DESIGN REVIEW BOARD

DRB2016-22

Design Review for new
construction of two
office buildings and
associated site work

BROADWATER BAY BUSINESS PARK - LOT 2B: OFFICE SUITES

SITE PLAN

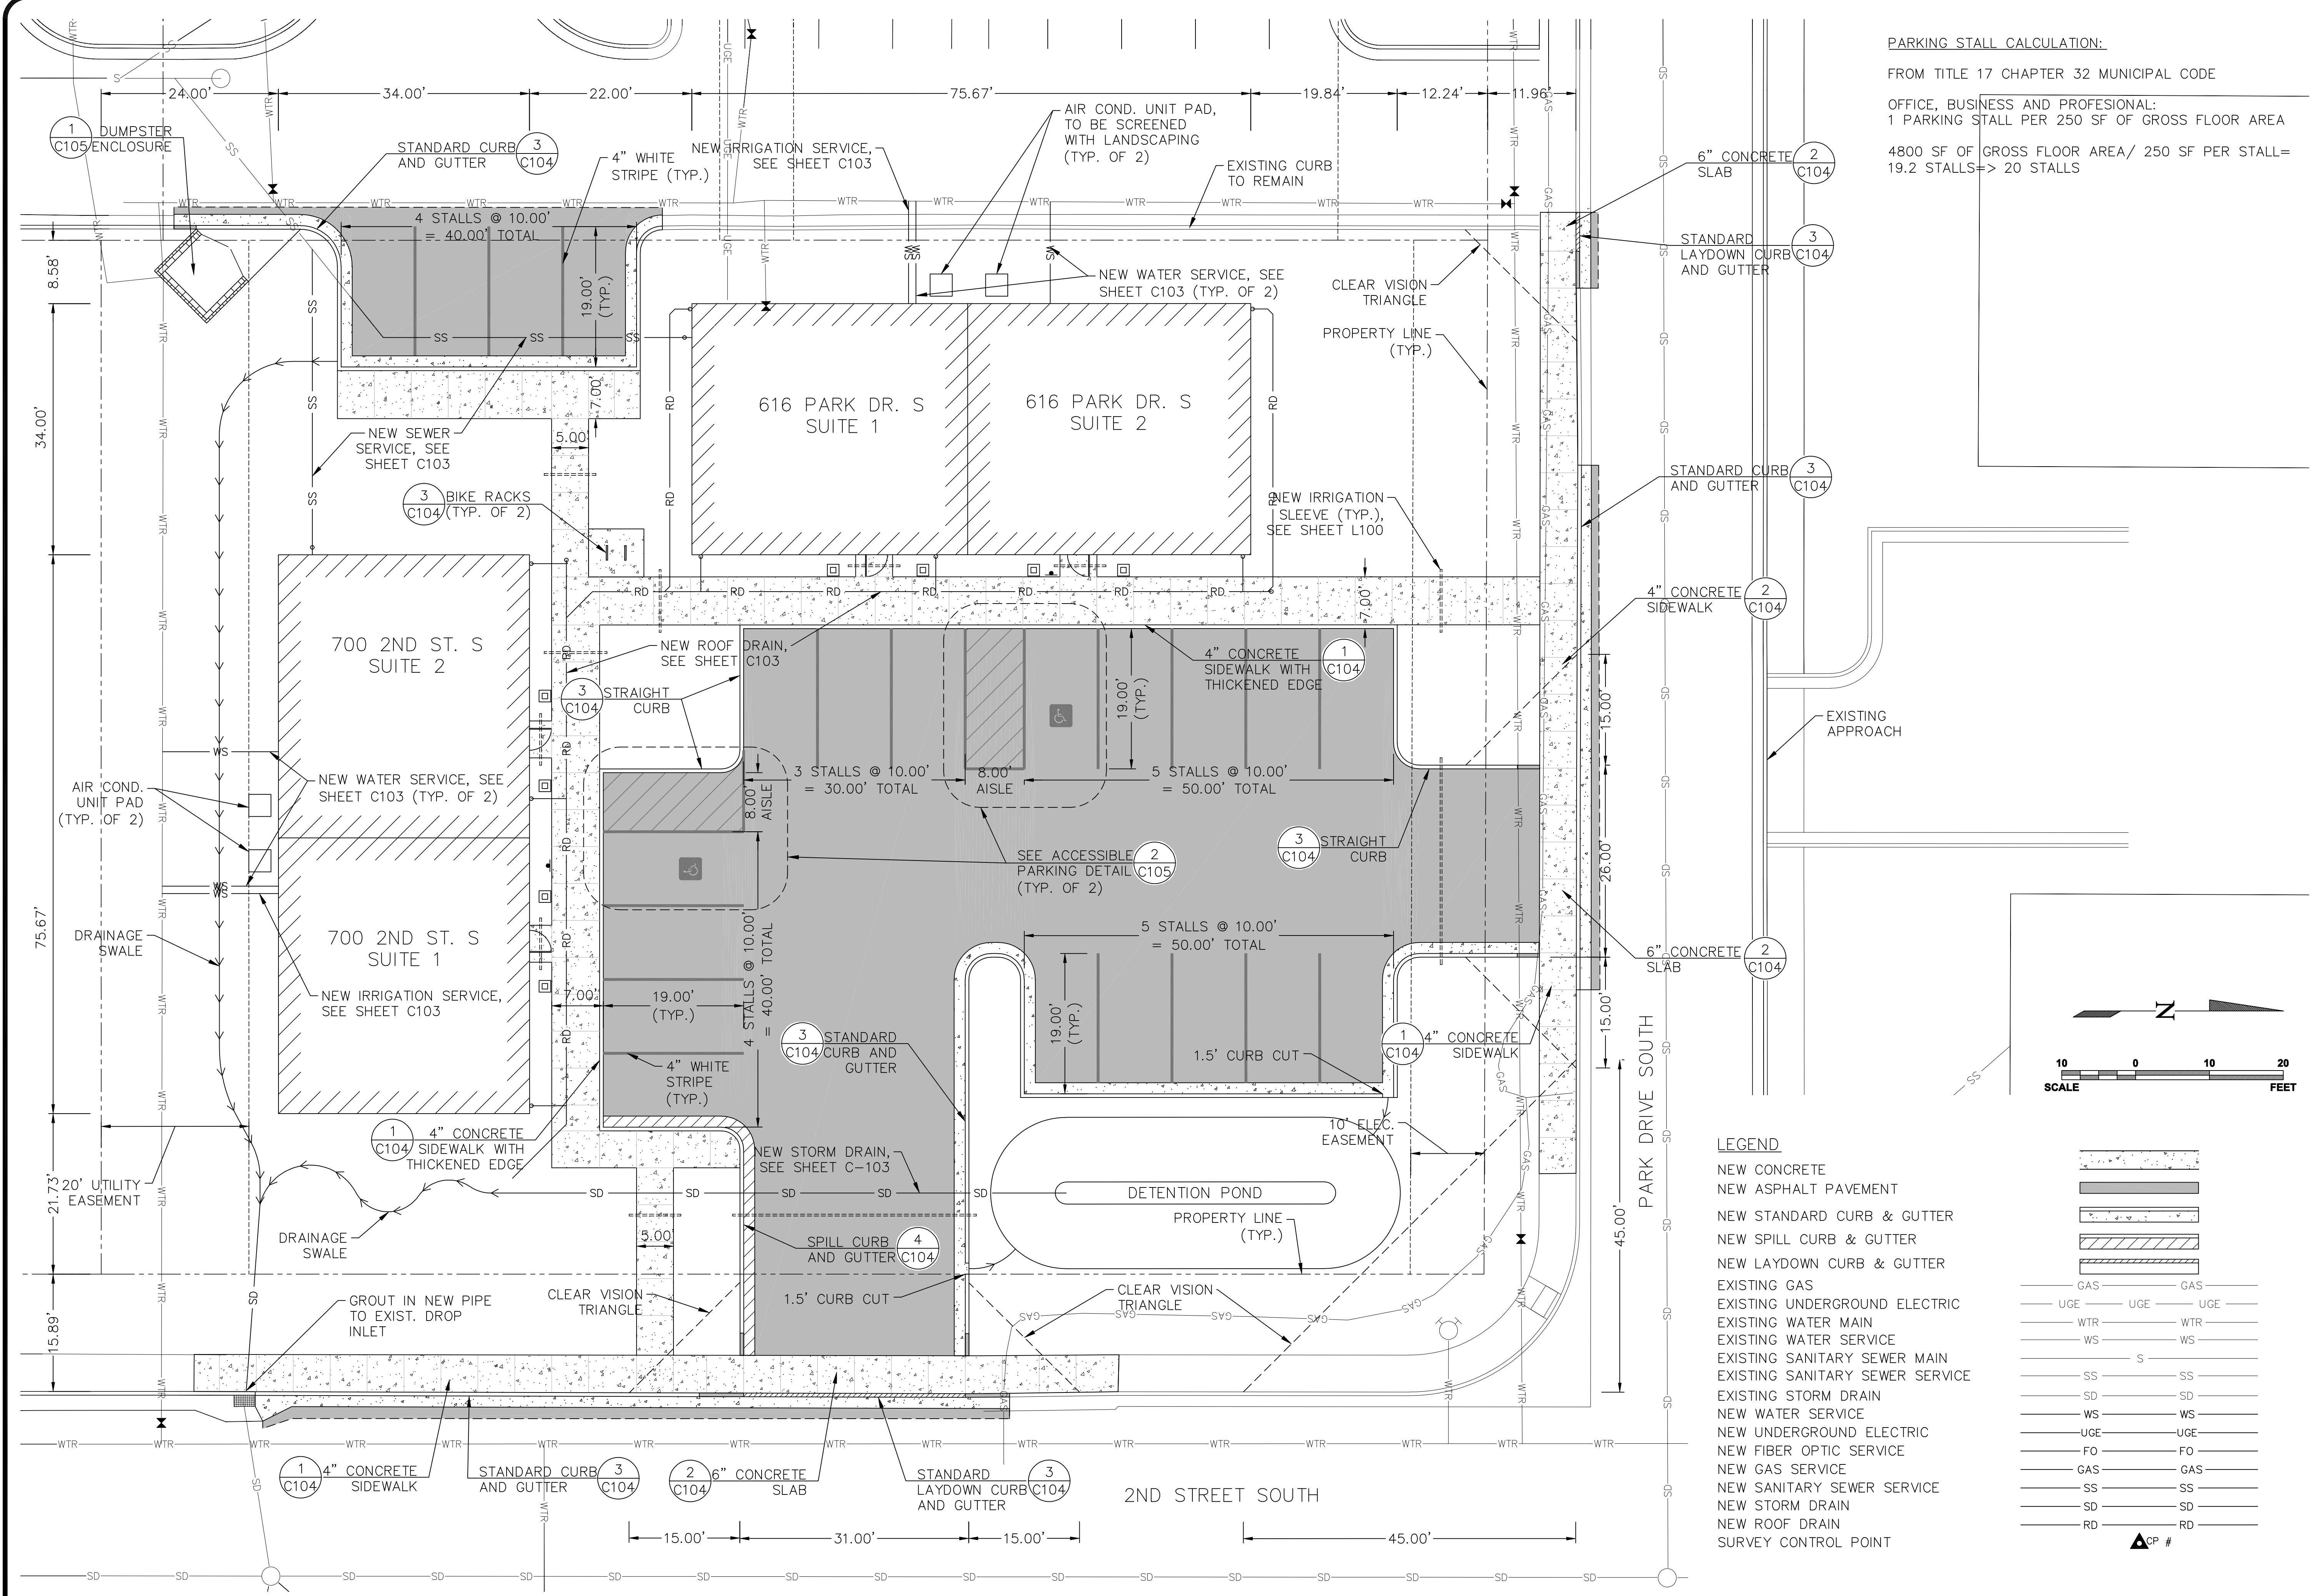
The site plan includes two new curb cuts, one off of Park Drive South and one off of 2nd Street South, both of which are main access points to the parking lot. The conceptual parking layout shows 21 parking spaces, two of which will be ADA accessible. This meets the code requirements for office buildings, which require one parking space per 250 square feet of gross floor area or 1.1 space per employee, whichever is greater. The location of four of the parking spaces will be accessed off of the adjacent property. A shared parking and access agreement shall be submitted during the building permit process. The applicant is also proposing bicycle parking located between the two proposed buildings just off of the sidewalk.

The applicant has proposed new sidewalks along parts of both street frontages to tie into the existing sidewalk at the northwest corner of the property. The applicant has also incorporated interior sidewalks into the site design to provide safe pedestrian access. Per Title 17, sidewalks shall be constructed when necessary to provide safe pedestrian access to and circulation within the project, therefore a 5-foot minimum is required for all sidewalks. The interior sidewalks are 7 feet wide adjacent to the parking spaces in order to compensate for vehicle overhang.

- A. The proposed project shall be developed consistent with the conditions in this staff report, all codes and ordinances of the City of Great Falls, the State of Montana, and all other applicable regulatory agencies.
- B. If after the approval of the concept development plan as amended by this Board, the owner proposes to expand or modify the conceptual development plans, the Director of the Planning and Community Development Department shall determine in writing if such proposed change would alter the concept for one or more review criteria. If such proposed change would alter the plan, the proposal shall be resubmitted for review as a new application.
- C. The applicant shall amend the site plan to show screening for the AC units.

LANDSCAPE PLAN

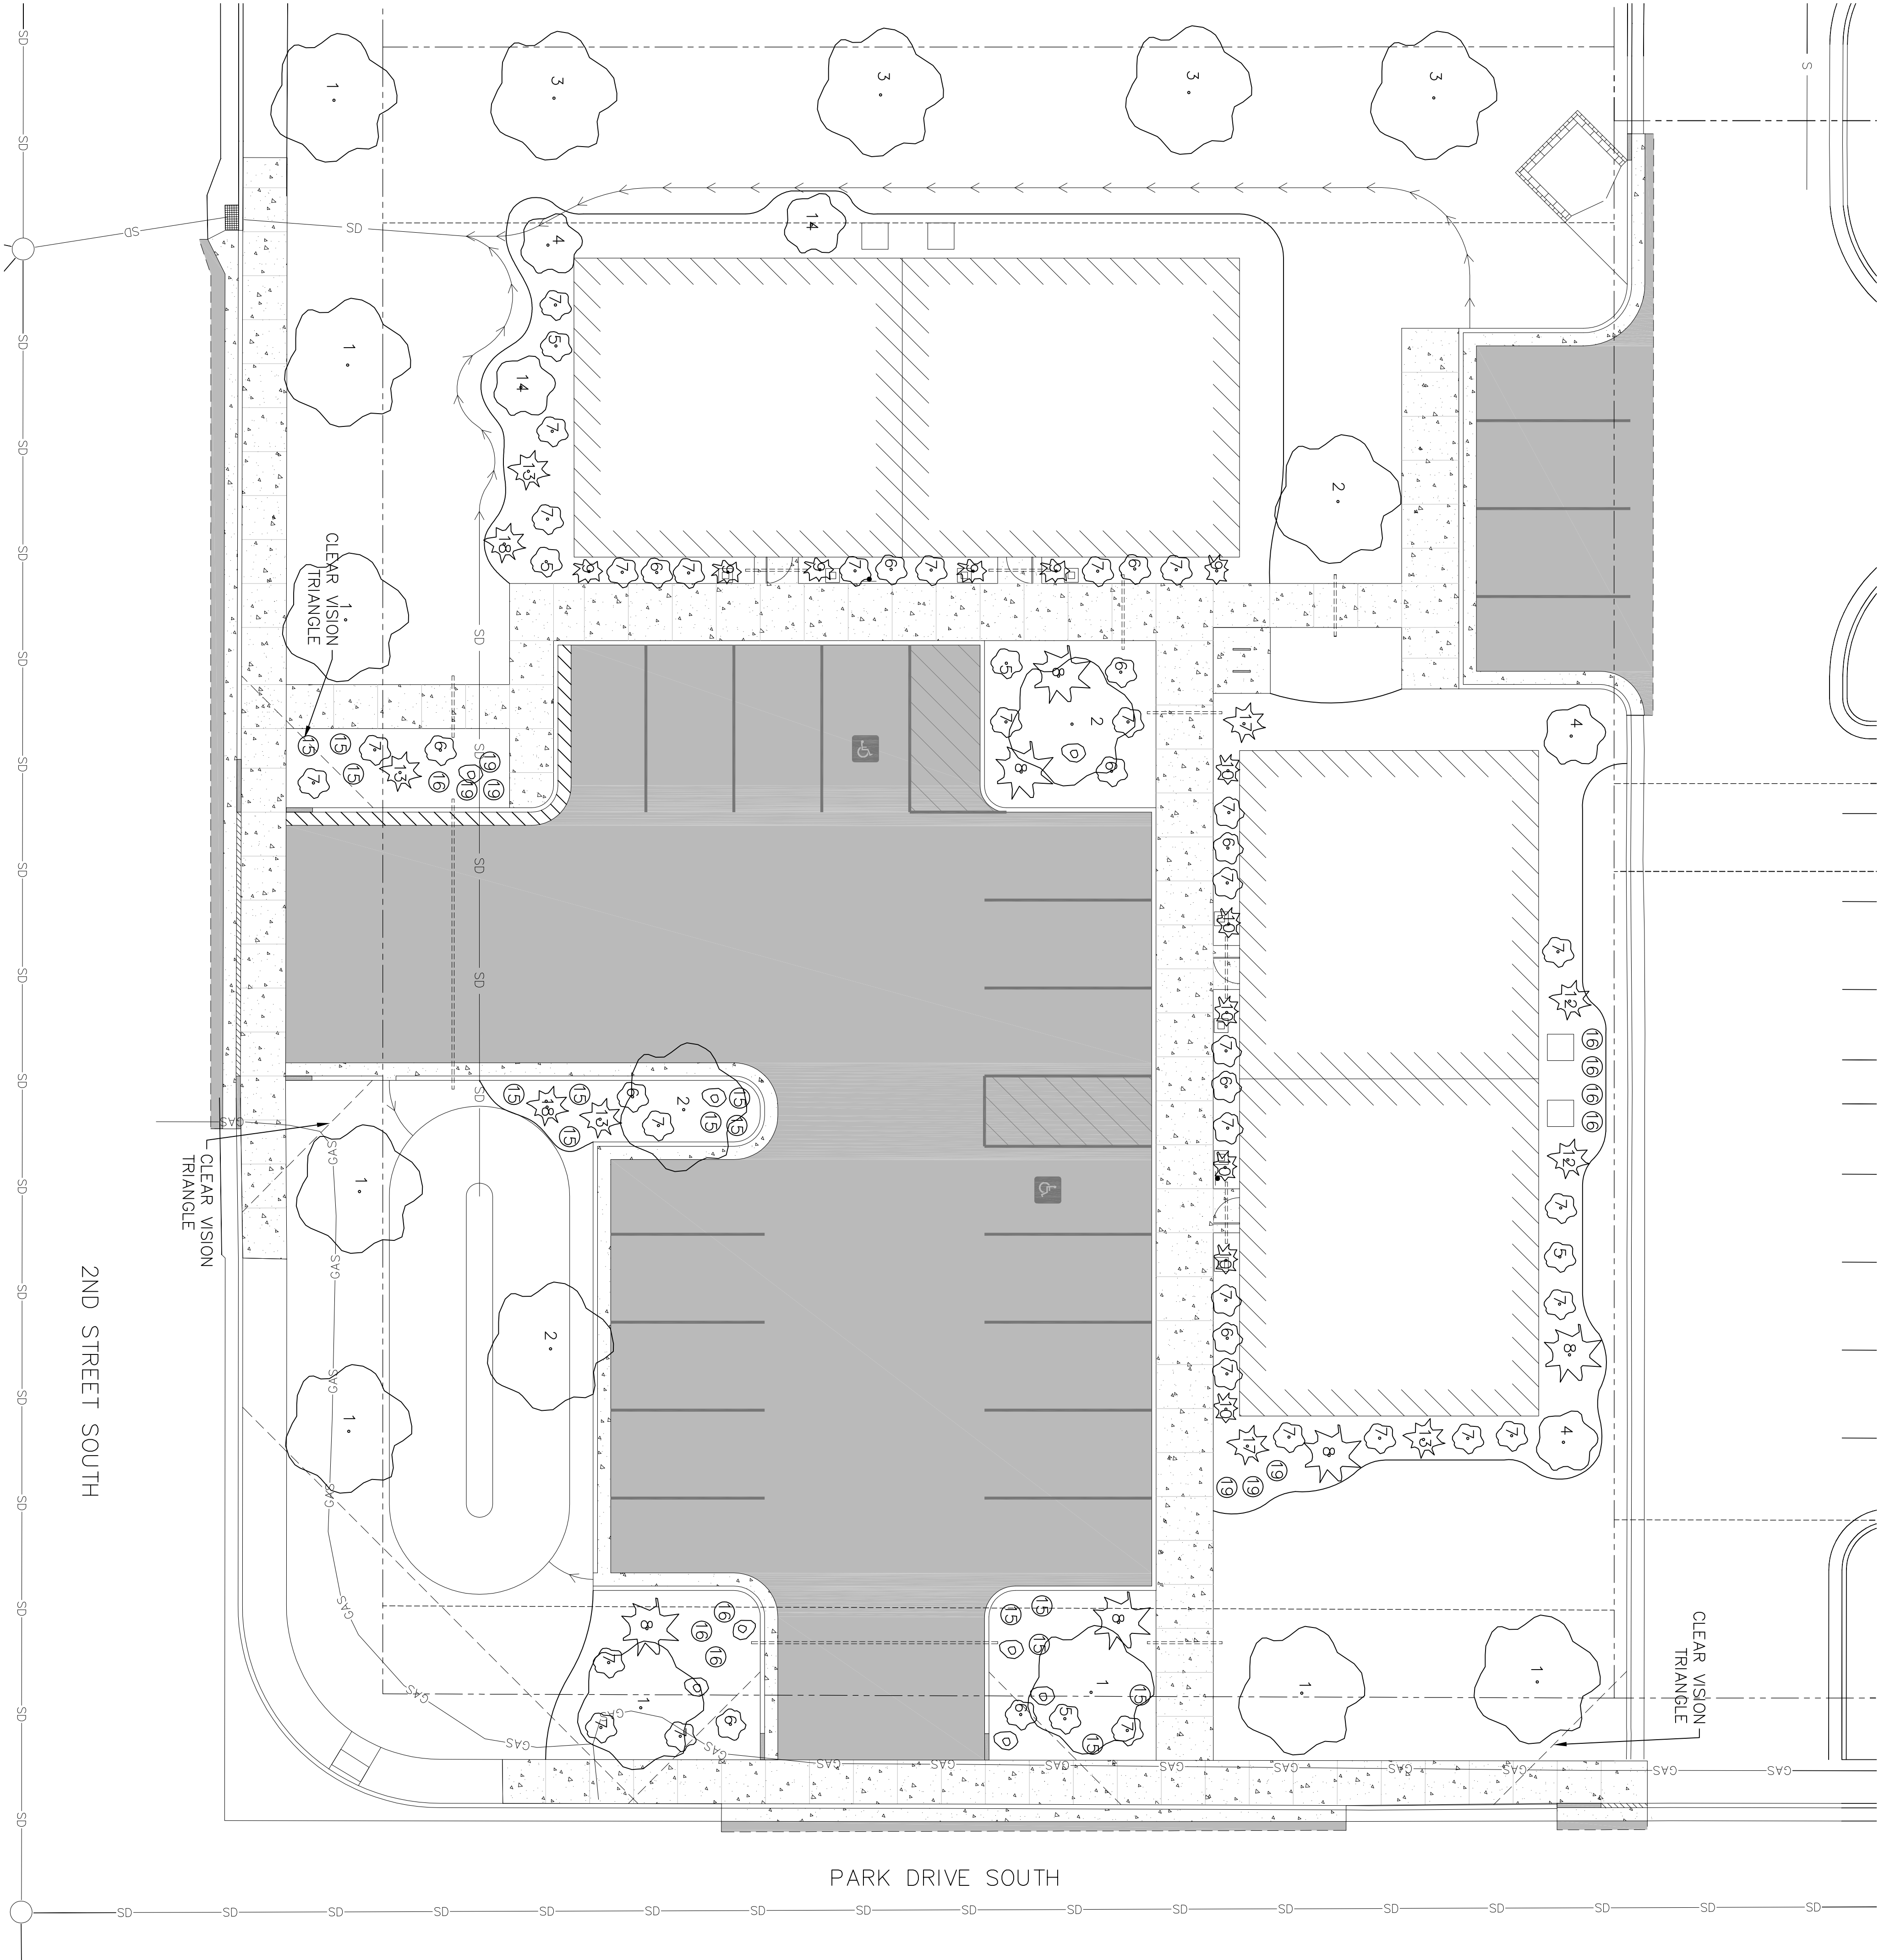
The proposed landscaping requires modification to meet the minimum requirements of the OCCGF. Paved or nonliving surfaces are the dominant texture within the interior of the site, with cement walkways accessing the building from the public right-of-way, an asphalt parking lot, and rock mulch in all landscape beds. The exterior of the site will be significantly improved by landscaping including grass, canopy trees, shrubs, and perennials.

The OCCGF Chapter 44 – Landscaping, requires that 15% of gross property area be landscaped. It further requires a minimum of one (1) tree and seven (7) shrubs planted and maintained per four hundred (400) square feet, or fraction thereof, of required interior landscaping, as well as one (1) boulevard tree for each thirty-five (35) lineal feet of street and avenue frontage. For this site, there are 9 boulevard trees, 10 interior trees and 70 shrubs required to be installed. The landscaping plan submitted meets the required rate of planting. The applicant is proposing a detention pond at the northeast corner of the subject property, adjacent to the 2nd Street South and Park Drive South intersection. The OCCGF states that by design, detention and retention areas shall be physically, functionally, and visually integrated into adjacent landscape areas. The applicant includes oversized rock in the bottom of the pond as a rock swale with plantings incorporated on the side slopes. The applicant will continue to work with Staff to integrate the design of the pond into the landscape as well as utilize the pond as a Low Impact Development feature. The landscape plan has been sent to the City Forester for review and any comments will be reflected in the revised landscape plan.
